November 13, 2019
NRC:19:029

Framatome Inc. Response to Request for Public Comment on the Draft Regulatory Guide DG-1327, "Pressurized Water Reactor Control Rod Ejection and Boiling Water Reactor Control Rod Drop Accidents" (Federal Register Vol. 84, No. 146, 36961, dated July 30, 2019; Docket ID NRC-2016-0233)

Enclosure 1:
Framatome Comments on DG-1327

Figure 2: Similar hydride-assisted PCMI-RIA failure mode for PWR (CWSR) and BWR (RXA) cladding types

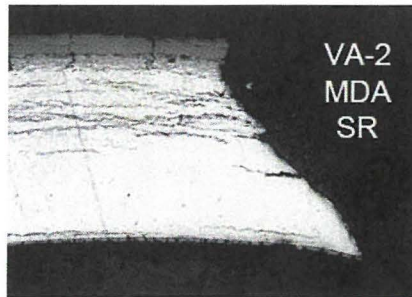
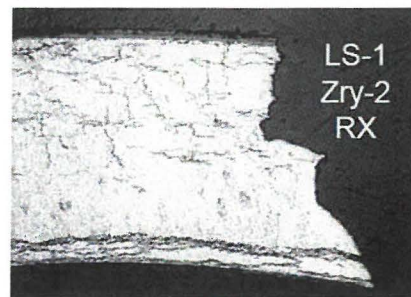
3. The overall cladding ductility has a negligible impact on the hydride-assisted outside-in cracking mechanism in the initial PCMI phase of RIA transients – this was documented in the PIE for the NSRR tests, which show typical final ductile failure due to the stress

intensification at the tip of the crack exceeding the ultimate tensile strength (UTS) (illustration in Figure 2)

Figure 3: Hydride distribution before and after a power ramp, showing small region next to the liner that is affected by liner soaking effect

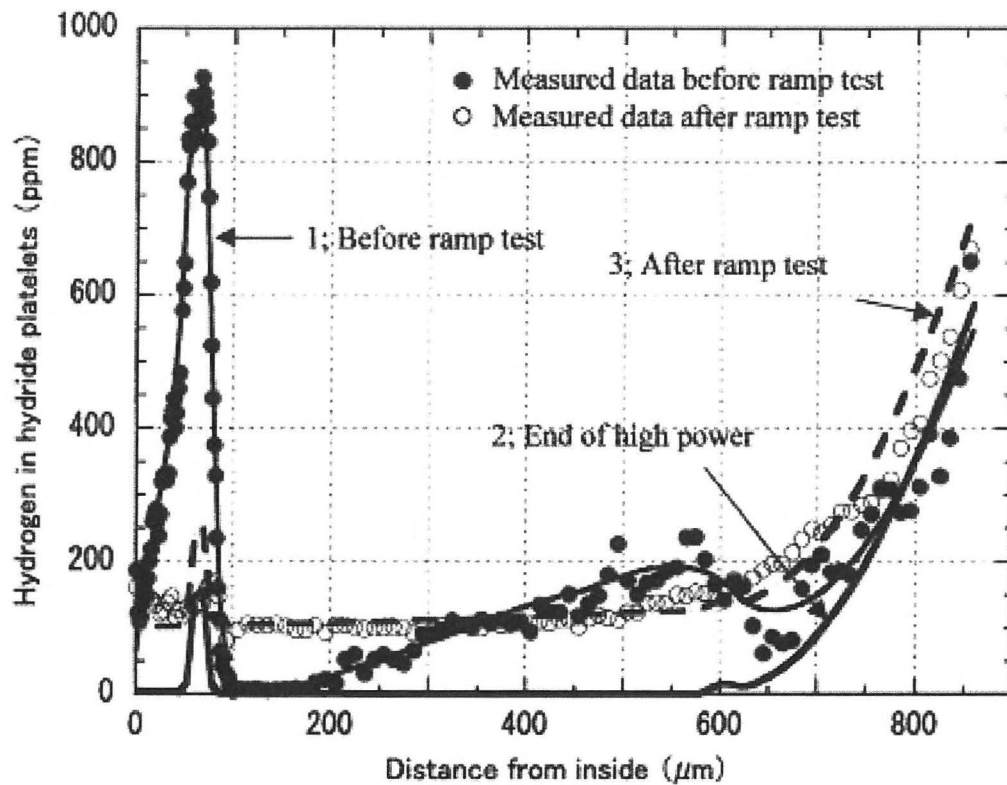
4. During normal operation and cool downs, the less alloyed liner at the cladding inner surface soaks up some of the hydrogen from the inner half of the cladding, but the outer hydride structure is not significantly affected – this is because the hydrogen diffusion is directed down the temperature gradient and thus quickly balances the concentration gradient created by the liner in the opposite direction– this is illustrated by Figure 3 from Reference 4, which shows that the hydrogen in the liner migrates down the temperature gradient during the power ramp over a small region next to the liner, which was also the region that supplied hydrogen to the liner during reactor operation.

Figure 4: Example PCMI Cladding Failure Threshold – Non-Liner RXA Cladding below 500 Degrees F

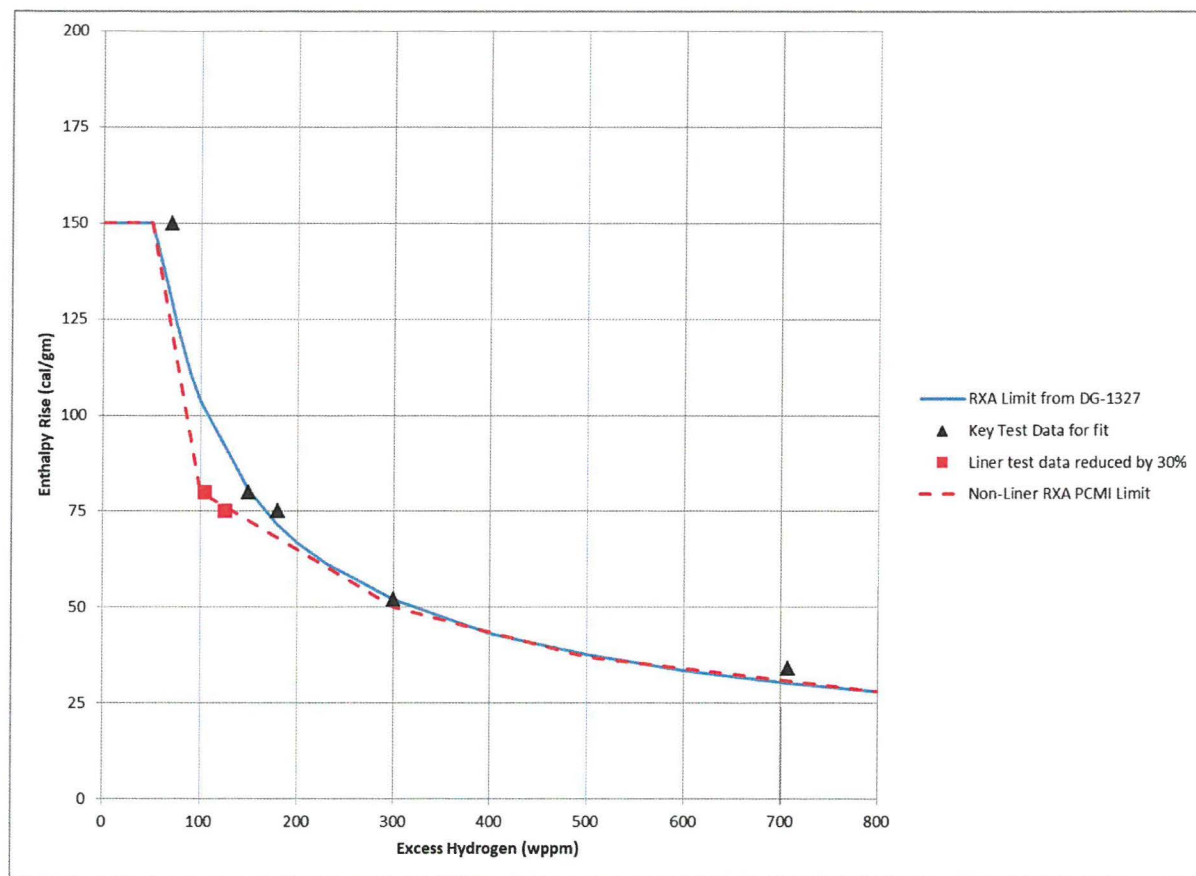
Alternative Proposal: If the proposal above is not considered an acceptable proposal, then revise Section 1.2.3 to provide adjusted PCMI limits for non-liner RXA cladding.

PCMI limit curves for non-liner RXA cladding materials can be developed by adjusting the hydrogen content of the liner RXA cladding tests to account for the influence of the liner on the hydrogen distribution in the bulk cladding material. Examples of adjusted PCMI limit curves are provided below in Figures 4 and 5.

Revised PCMI limit curves for non-liner RXA cladding can be developed by reducing the excess hydrogen content for the group of failed tests in the range of 150-200 wppm (see Reference 1, p. 47). Using this technique, PCMI limit curves are provided below in Figures 4 and 5. After the shift, the data points do not align well with a power function as proposed in Reference 1, p. 47. While more exotic function combinations could be used to fit the data, a simple, piecewise linear fit is provided in Figures 4 and 5.

Figure 6: Hydrogen Distribution from Hayashi et al (Reference 2)

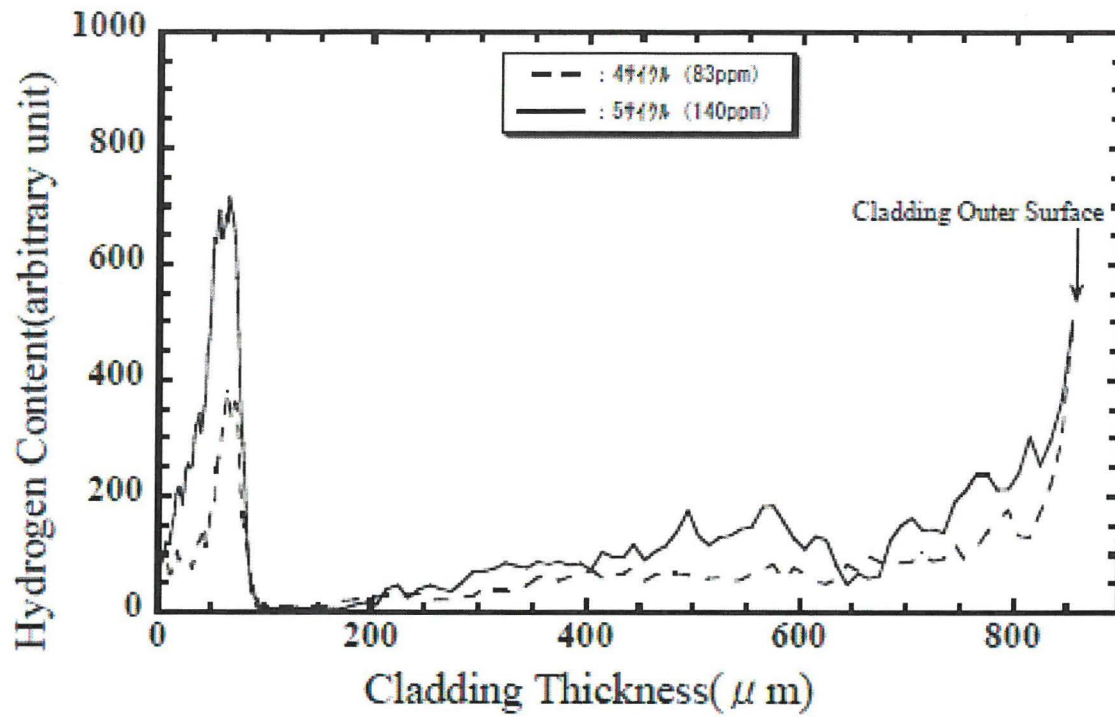
Hydrogen distribution through the cladding wall has been measured by Hayashi et al (References 3 and 4) and also in the NFIR-V project (References 5 and 6). Figure 6 shown below is taken from Reference 2 and demonstrates the preferential accumulation of hydrogen in the liner at the interface with the bulk cladding. These distributions (References 3 through 6) were used to evaluate the reduction in the bulk metal hydrogen concentration due to the soaking effect of the liner. On average, the soaking effect of the liner reduces the bulk hydrogen content by ~21% compared to the total hydrogen value. The upper bound is < 30% reduction. Figure 7 shows the results of the evaluation.

Figure 7: Hydrogen Concentration Reduction due to Linear Soaking Effect

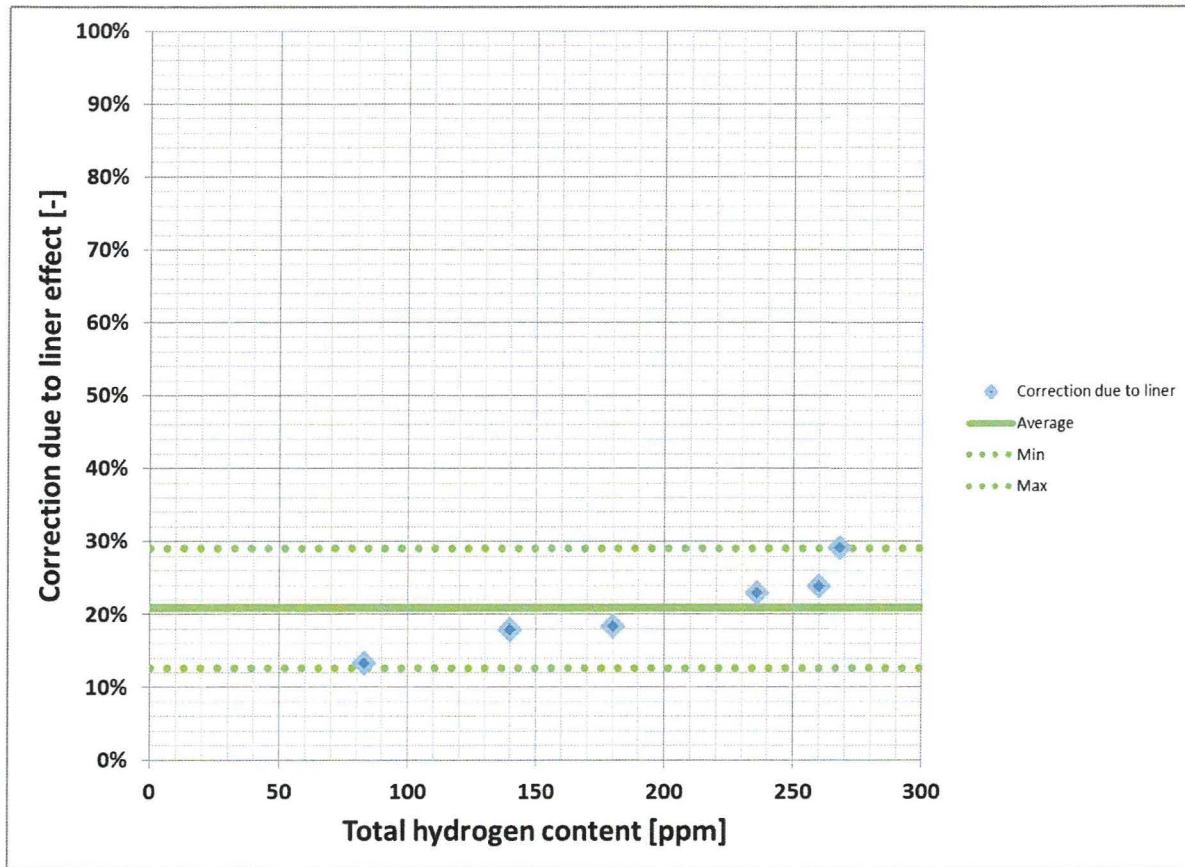
These results were also used to evaluate the hydrogen distribution in more than 30 Framatome proprietary metallographic cross-sections of lined Zr-2 RXA cladding from multiple BWR plants. The evaluation concluded that an upper bound reduction factor of 30% is conservative for total hydrogen content in excess of 800 wppm.
